Your Ref.: TPB/A/NE-KTS/525  
Our Ref.: 2105PA-L014  
Date: 28<sup>th</sup> August 2023

**Re : Response to Departments' Comments**  
**Proposed Residential Development (Houses) and Minor Relaxation of**  
**Plot Ratio Restriction at Various Lots in D.D. 94, Hang Tau Tai Po,**  
**Kwu Tung South, Sheung Shui, New Territories**  
**(Application No. A/NE-KTS/525)**

SECTION AA' (Rev.A)

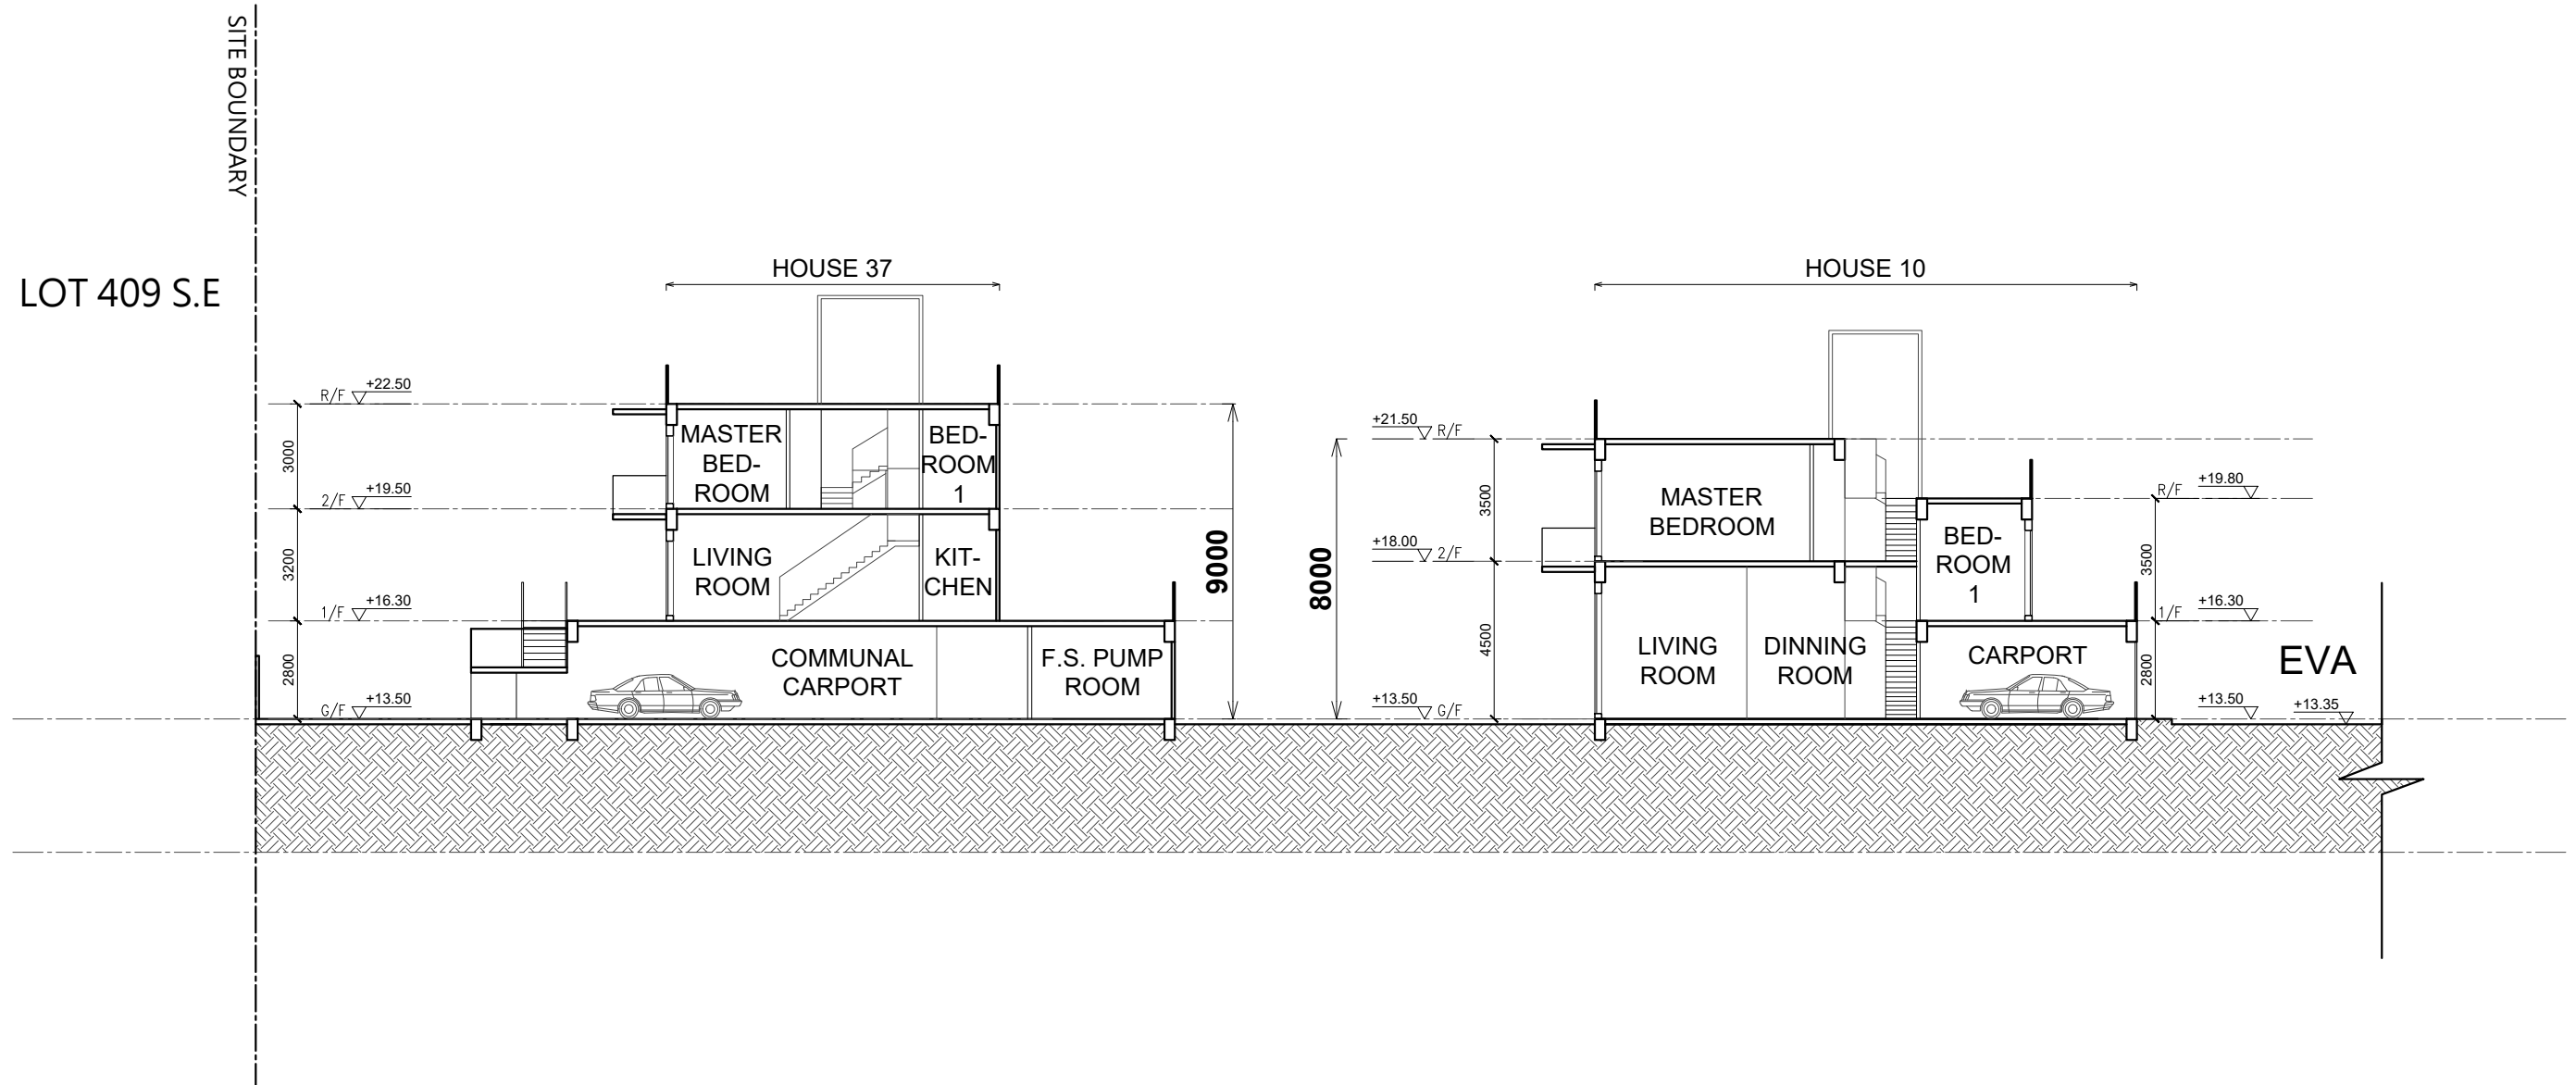
<p>2. Please clarify the building heights of the proposed houses as they are not tally on the application form and section plan.</p>	<p>This is to confirm that the building height is 8m/21.5mPD (for House 1 to 35) and 9m/22.5mPD (for house 36 to 42) respectively.            Please refer to attached revised section plan-Section AA' (Plan 9 -Rev. A) for your ease of reference.</p>
<p>3. Whether the proposed access road (Access Road B) would be surrendered to the Government upon completion.</p>	<p>Yes. The access road would be surrendered to the Government upon completion.</p>
<p><b>Comments from the Water Suppliers Department</b>            (Contact Person: Ms Victoria SUEN at            Tel.:2152 5752)</p>	
<p><u>Other Detailed Comments:</u>            Existing water mains as shown in the enclosed sketch are inside the proposed lot and will be affected. The applicant is required to either divert or protect the water mains found on site. (Con't)</p>	<p>Noted</p>
